STAFF RECOMMENDATION

808 Shelby Avenue
March 20, 2019

Application: New Construction—Addition; Setback Determination
District: Edgefield Historic Preservation Zoning Overlay
Council District: 06
Map and Parcel Number: 082160X00100CO & 082160X00200CO
Applicant: Jeff Checko
Project Lead: Melissa Sajid, melissa.sajid@nashville.gov

Description of Project: Application is to construct deck additions to both side façades, and to reduce both side setbacks from five feet (5') to three feet (3').

1 NORTH ELEVATION (REAR)
1/4" = 1'-0"

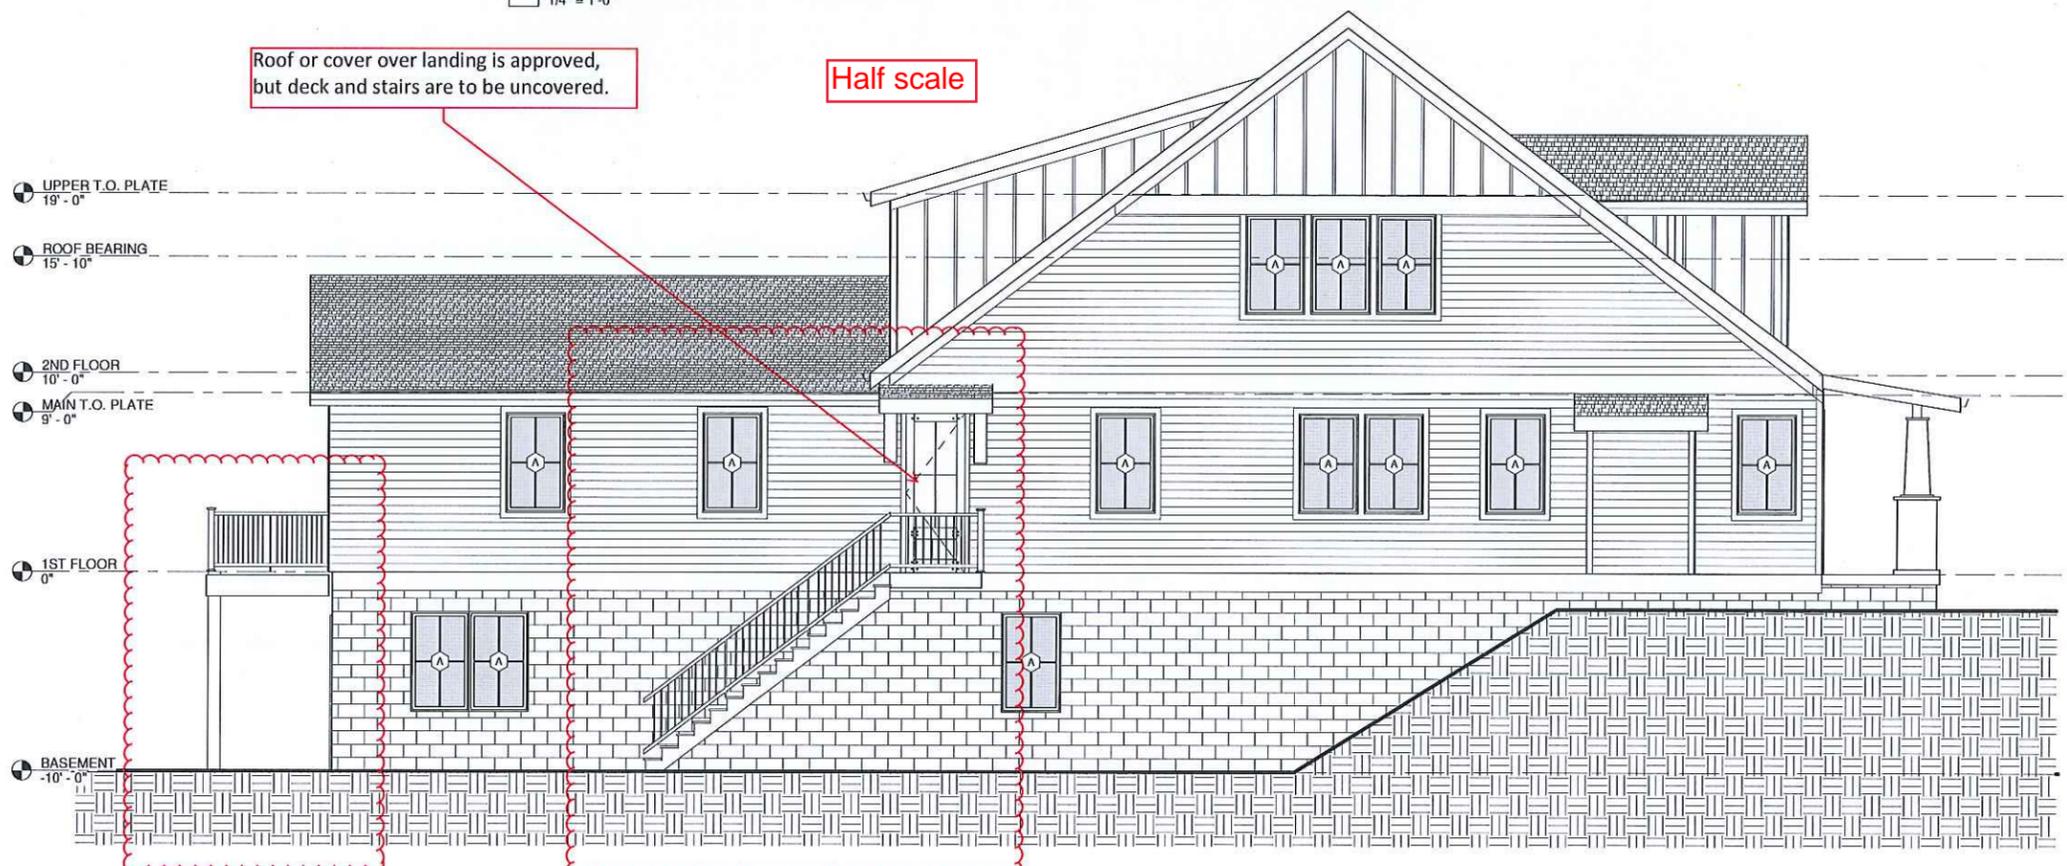
Roof or cover over landing is approved, but deck and stairs are to be uncovered.
